DOCUMENT CHANGE REQUEST

DCR number 381	Changes required for: General	Originator: S Jeffery
Date: 2007/10/16	Date sent: 2007/10/16	Organisation: ESA/ESTEC
Status: IMPLEMENTED

Title:	Transistors Field-Effect N-Channel, based on types 2N4391/2N4392 and 2N4393		
Number:	5205/003	Issue:	1

Issue 2 - Draft A	October 2007

1.6.1 Metal Can Package (TO-18) - 3 lead

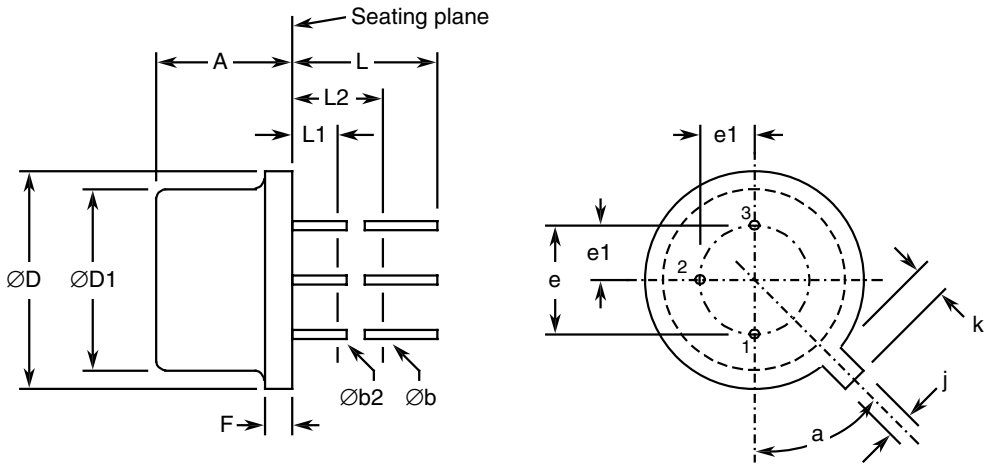
8. Figure 2 re-named "Physical Dimensions and Terminal Identification" and amended to reflect the 'standardised' TO-18 package. Notes amended.

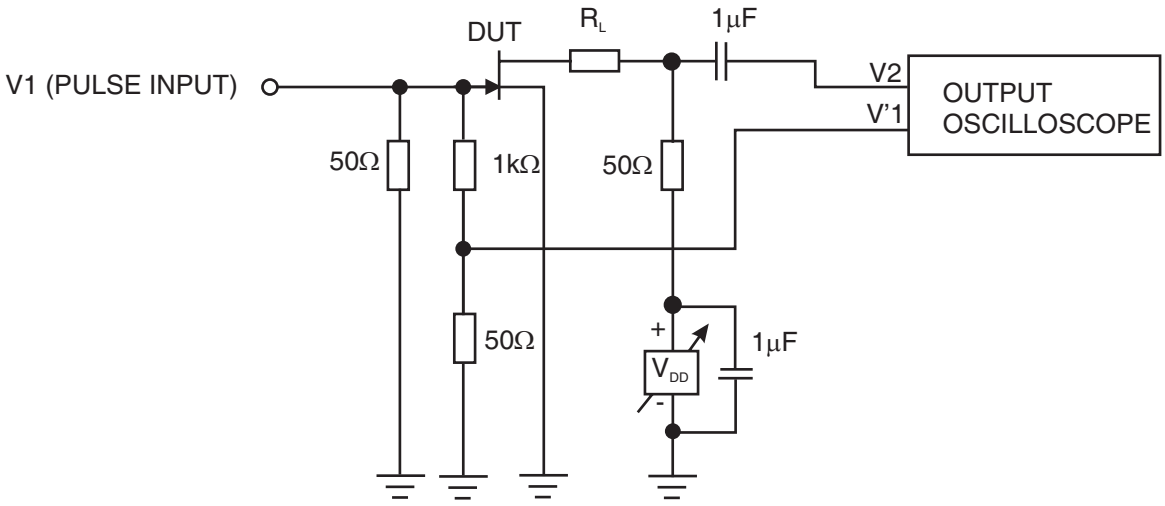
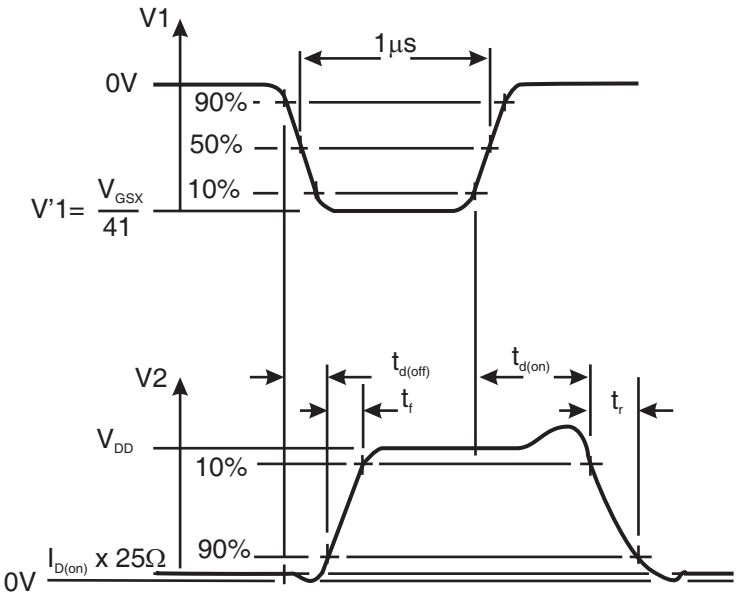
25. Figure 4 amended and moved to be a note (Note 3) to Room Temperature Electrical Measurements.

3. t_r, $t_{d(on)}$, t_f and $t_{d(off)}$ shall be measured using the following test circuit. The input waveform shall be supplied by a pulse generator with the following characteristics: Z_{out} = 50Ω, $t_r = t_f \leq$ 500ps, Pulse Width = 1µs, Duty Cycle = 10%. The output waveform shall be monitored on an oscilloscope with the following characteristics: Z_{in} = 50Ω, $t_r \leq$ 400ps.
